Addendum No. 1

Project: 2017 Renovations
Dillsboro Elementary
Dillsboro, Indiana

Proj. No: 1649.01

Date: August 11, 2017

Area "A" Lighting Plan

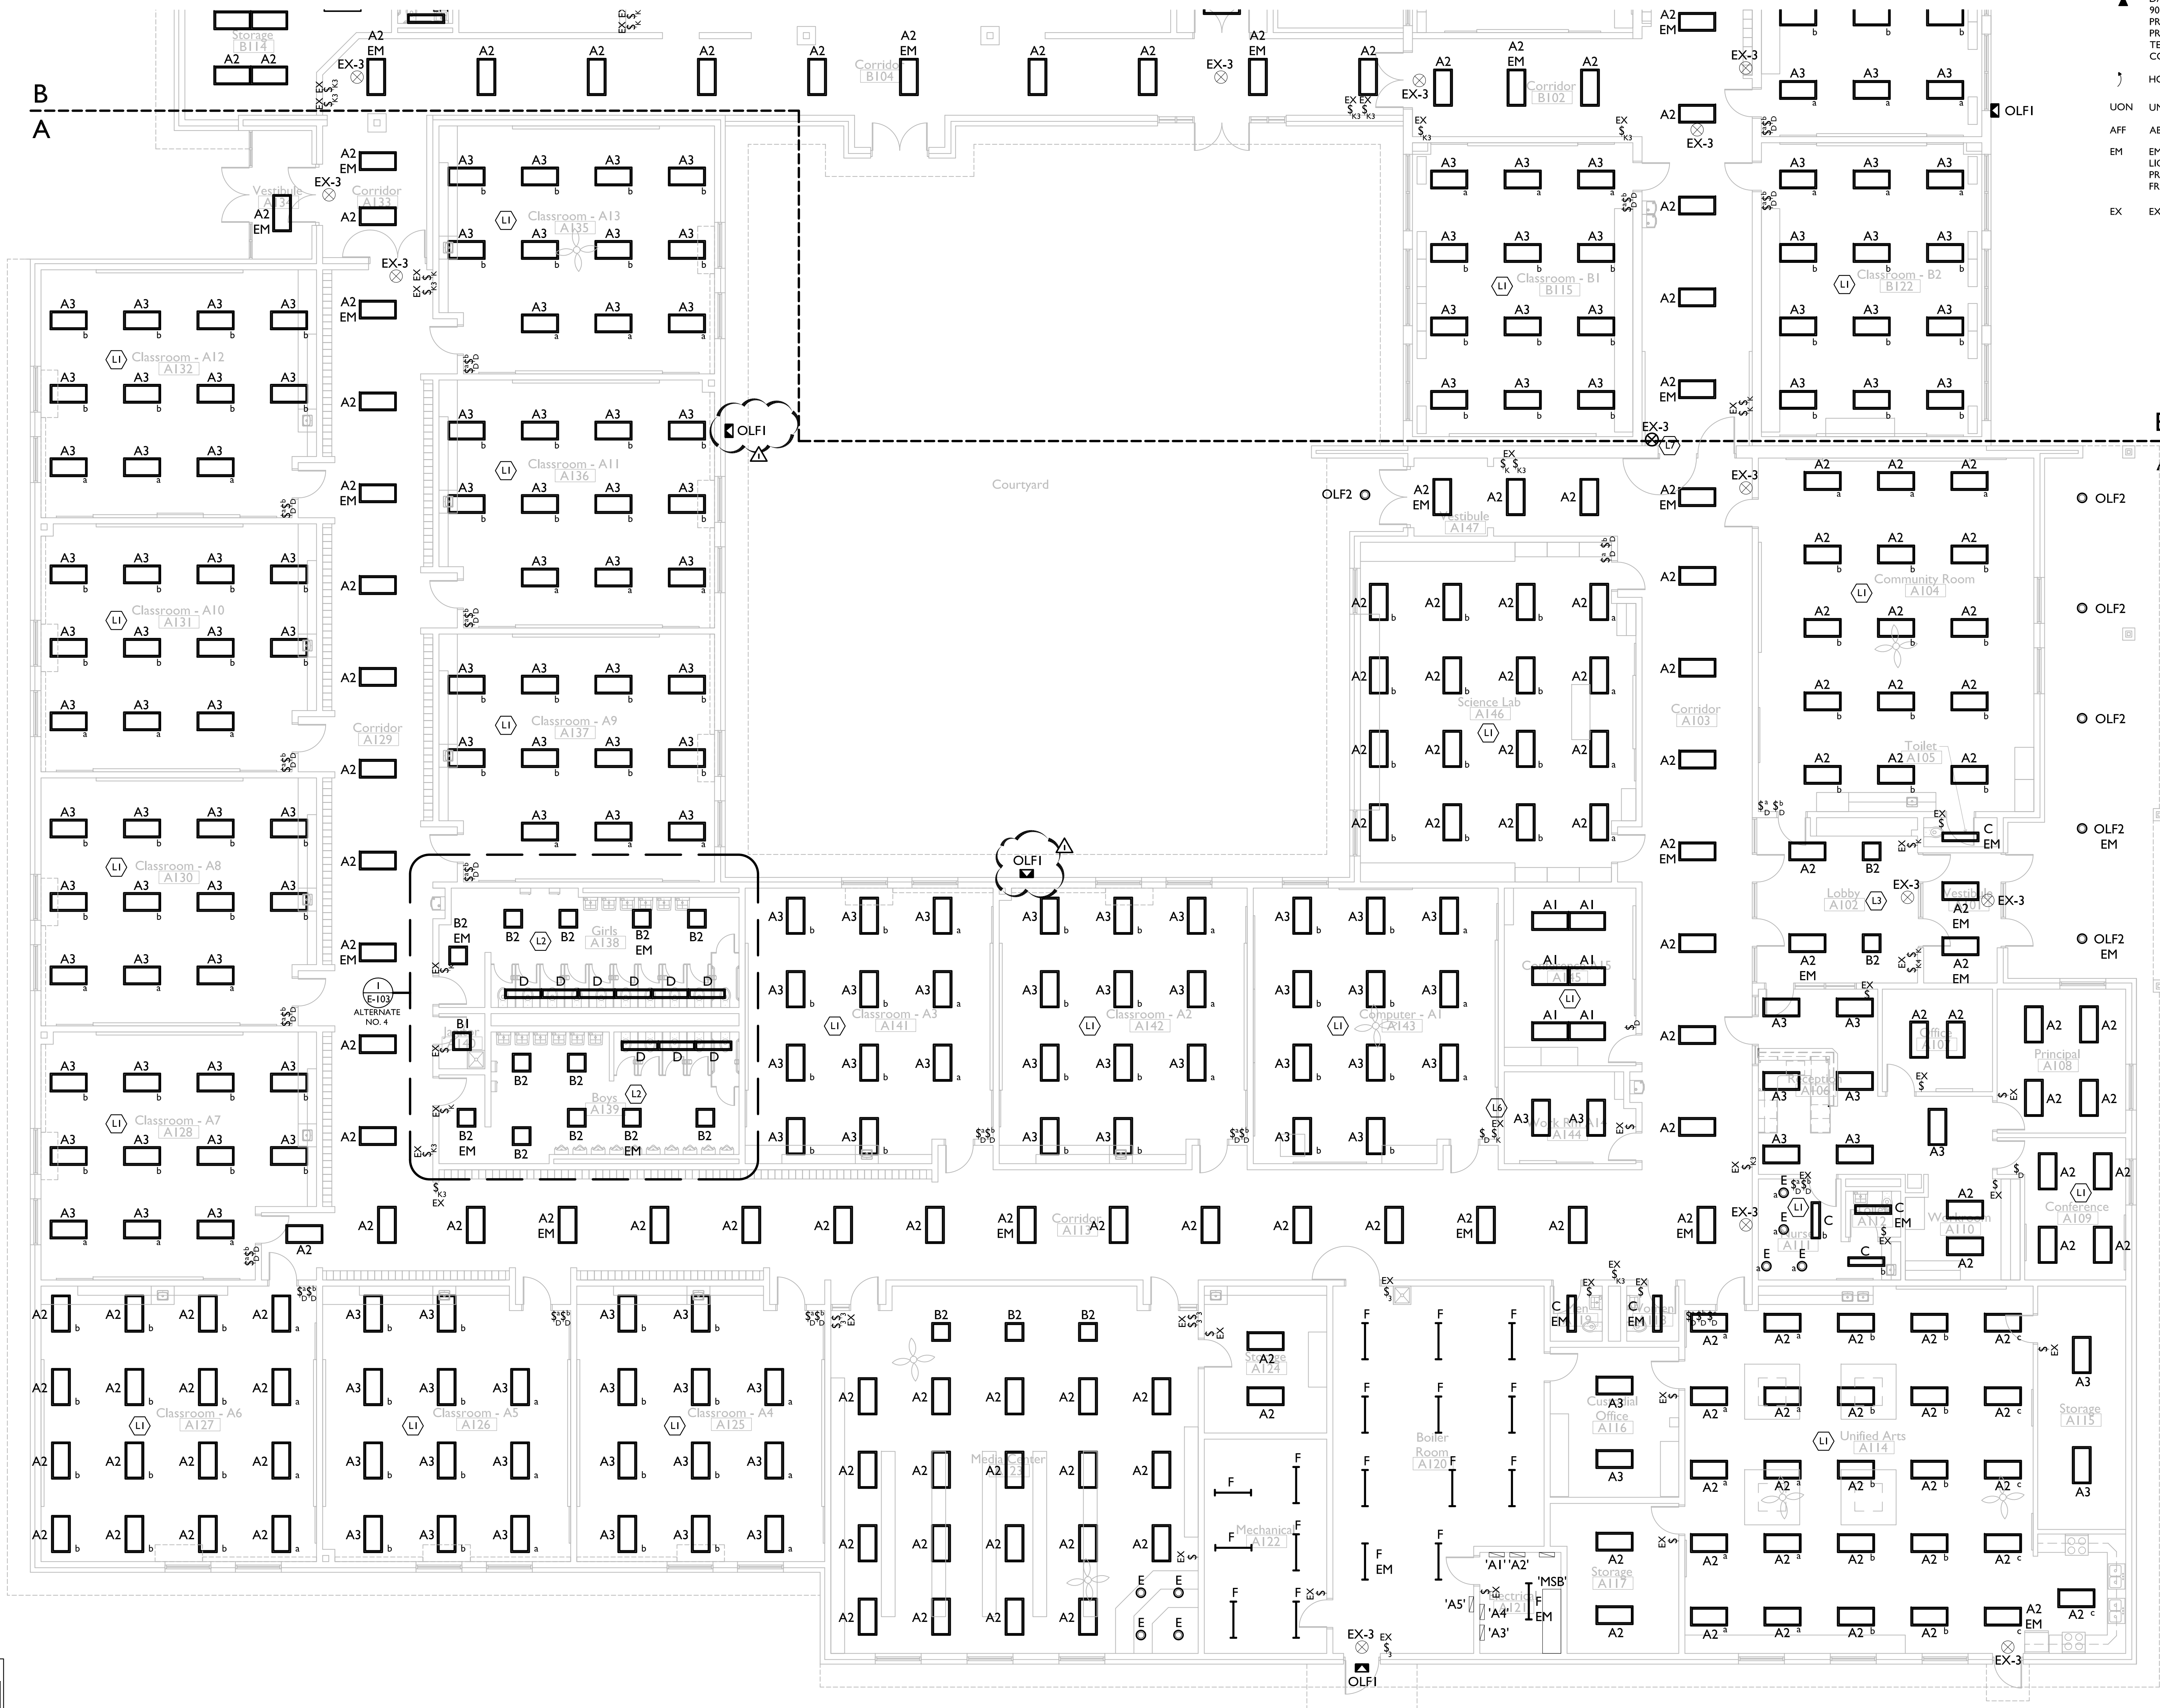
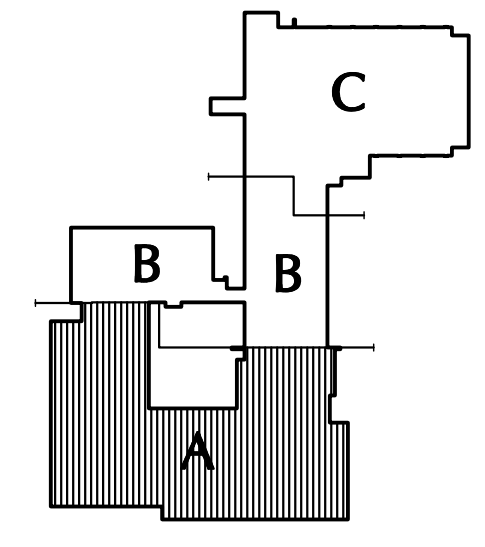
- 24. All E-100 Drawings
Add Lighting Plan Keynote L8 as follows:
L8 Install new light switch to separate closet light fixture from classroom light fixtures.

- 25. E-101 Area "A" Lighting Plan
Replace existing drawing in its entirety with the attached drawing; refer to clouded areas for revisions.

- (L6) EXISTING KEY SWITCH FOR COMPUTER POWER TO REMAIN.
- (L7) INSTALL EXISTING EXIT LIGHT AT NEW LOCATION. EXTEND EXISTING LIGHTING CIRCUIT TO NEW LOCATION AS REQUIRED. INSTALL CIRCUIT IN SURFACE MOUNTED RACEWAY WHERE EXPOSED.
- (L8) INSTALL NEW LIGHT SWITCH TO SEPARATE CLOSET LIGHT FIXTURE FROM CLASSROOM LIGHT FIXTURES.
